**Delta Municipal Parking Lot Design -
ADDENDUM #1**

A1-PW2026-19

This addendum is being released to answer questions received on this RFP.

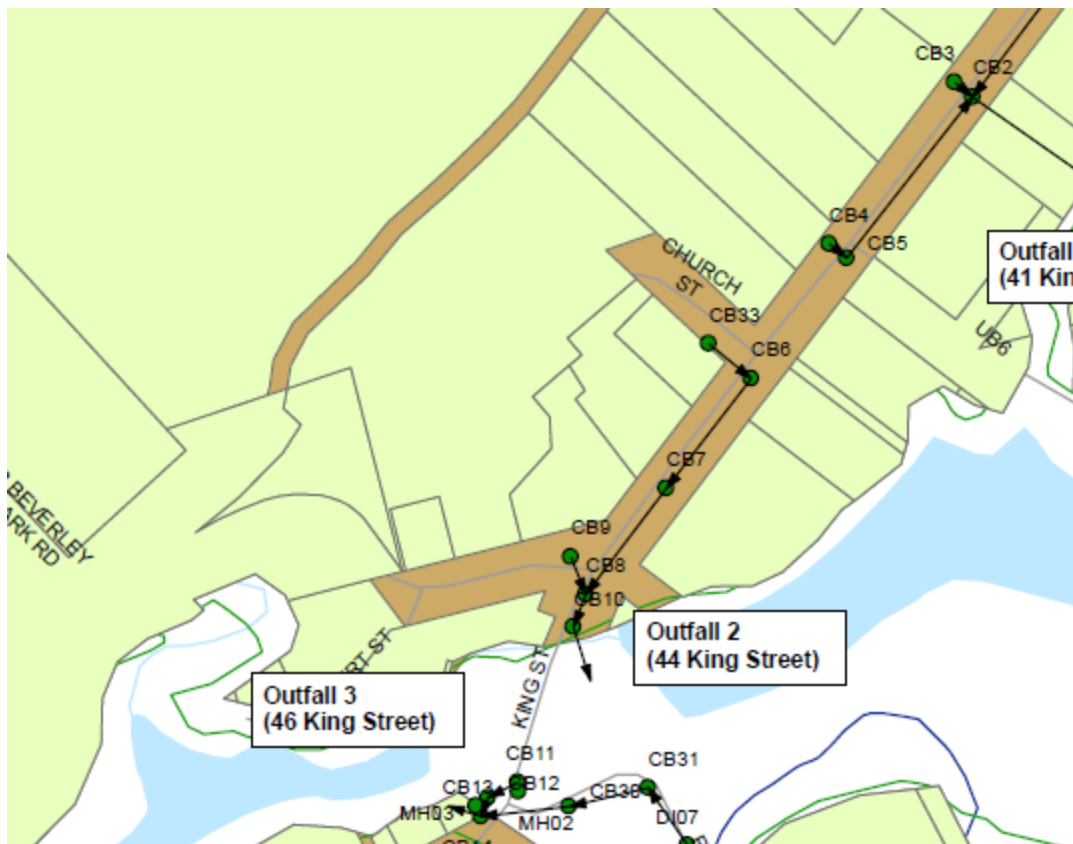
7. Q: Are there any existing site drawings, utilities mapping, or other investigation studies available that can be provided to us to reduce duplication of effort?

A: See picture below for locations of nearby storm water infrastructure.
